B. MODIFICATIONS TO THE PROJECT

B.1 115 KV SUBTRANSMISSION LINE MODIFICATIONS

Supplemental Draft EIR

Figure B-1

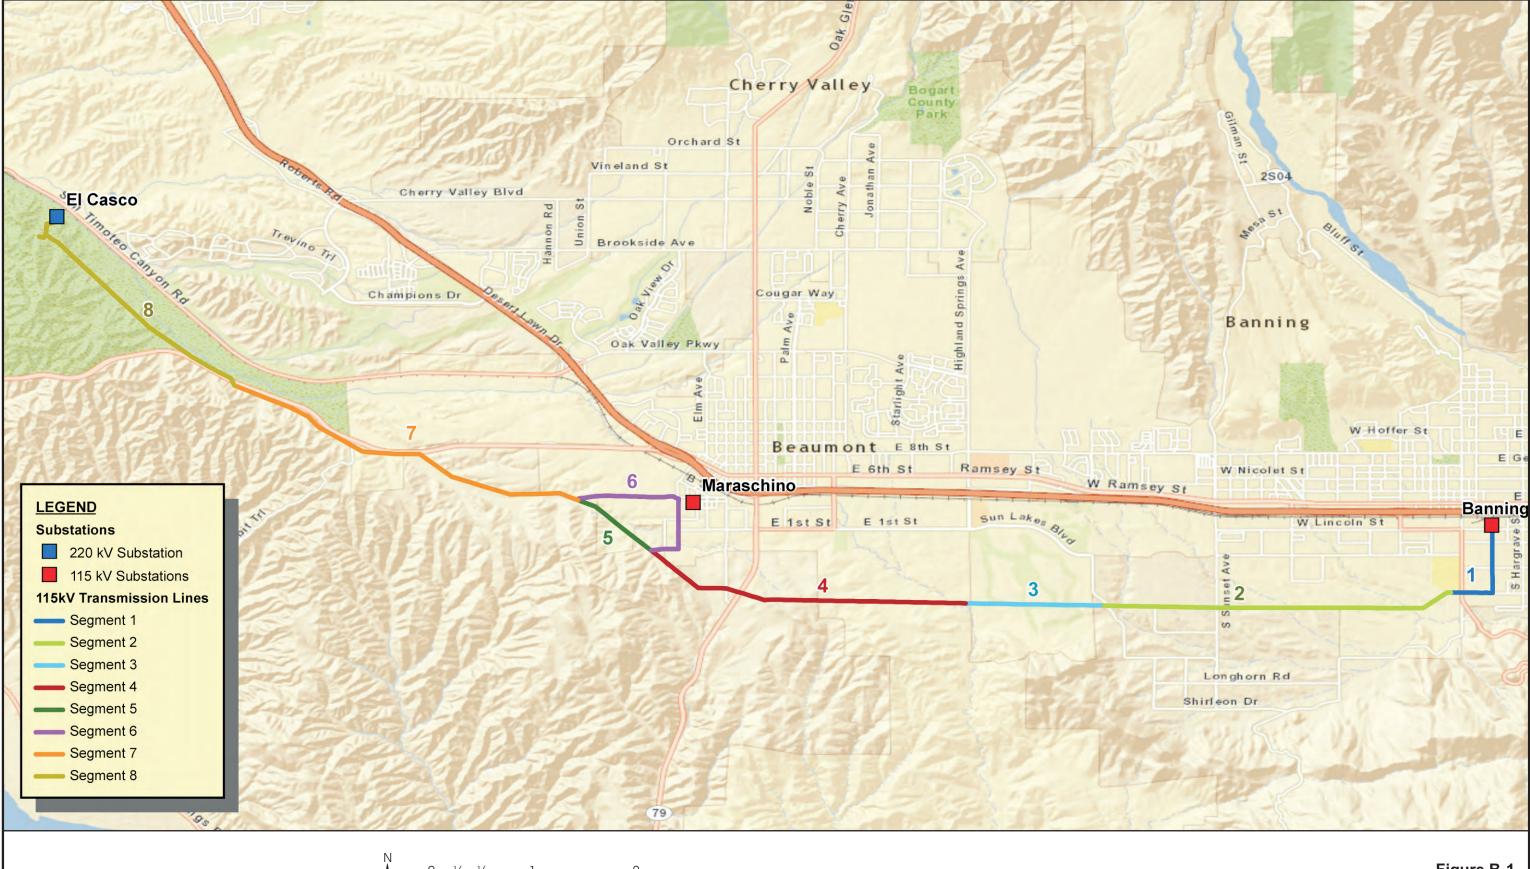
As part of the final engineering of the approved Project, SCE has determined that certain modifications to the preliminary design of the 115 kV subtransmission line element are needed, which differ from what was analyzed in the previously approved EIR (CPUC Decision 08-12-031, SCH #2007071076). To better manage and track construction resources, public notifications, and environmental reviews, the subtransmission line element of the Project was divided into eight segments of varying lengths, referred to as Segments 1 through 8, as shown in Figure B-1 (at the end of this section). The proposed modifications described in this document are confined to Segments 2 and 4 of the 115 kV subtransmission line (Figure B-2(a-i) located at the end of this section) and are presented in detail below.

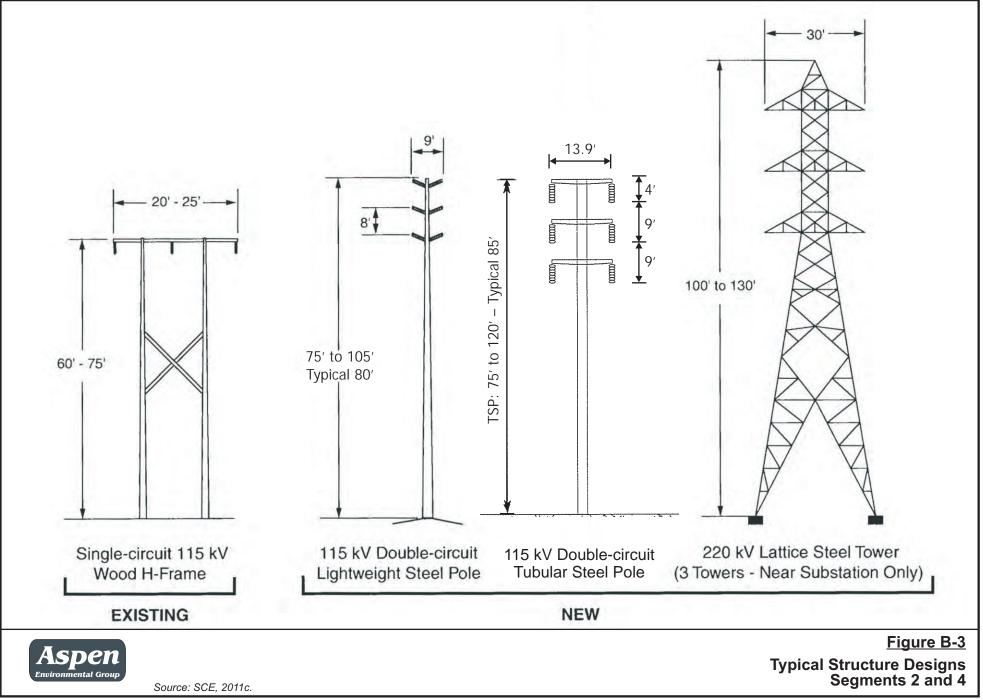
from the original 33 analyzed in the EIR. Of these 61 structures, 49 would be LWS poles (80%) and 12 would be TSPs (20%) (SCE, 2011a). As shown in Figure B-3 (located at the end of this section), the LWS poles would range in height from 75 to 105 feet and the TSPs would range in height from 75 to 120 feet (SCE, 2011b).

Within Segment 4, a total of 57 new structures would be installed to replace 25 existing H-frame, two existing three pole, and three existing single-pole wood structures. This represents an increase of 27 structures from the original 30 analyzed in the EIR. Of these 57 structures, 48 would be LWS poles (84%) and 9 would be TSPs (16%). As shown in Figure B-3 (located at the end of this section), the LWS poles and TSPs would both range in height from 75 to 85 feet (SCE, 2011c). These changes in the number of structures within Segments 2 and 4, which generally results from an increase in the number of LWS poles within these portions of the 115 kV alignment (TSPs would continue to be utilized at turns/angles, at drainage crossings, and at some road crossings as per the original design), represent basically a doubling in the number of structure heights within Segments 2 and 4 have increased substantially from the original design (65 to 85 feet tall) and would instead range from 75 to 120 feet.
